PATENT NO. 7,000,464

TITLE: MEASURING AND CONTROL OF LOW FLUID FLOW RATES WITH HEATED CONDUIT WALLS

> REQUEST FOR CERTIFICATE OF CORRECTION UNDER 37 C.F.R. 1.322

RESPONSE TO OFFICE ACTION DATED DECEMBER 20, 2004

FIG. 6

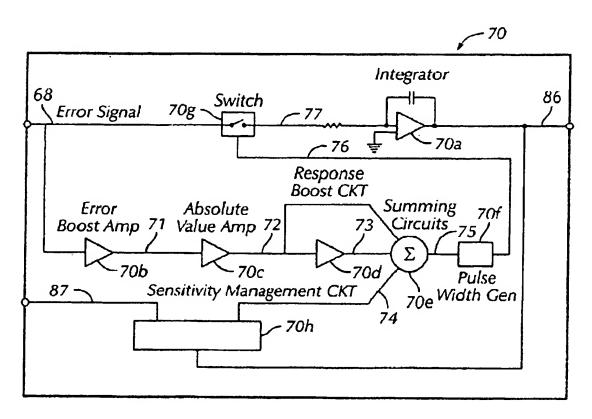
In the revised drawings, reference character B and reference numeral 40 have been added to Figure 1. Reference characters B and E have been added to Figure 4 as described in the specification. Reference numeral 70 has been added to Figure 6 in a manner consistent with Figure 4.
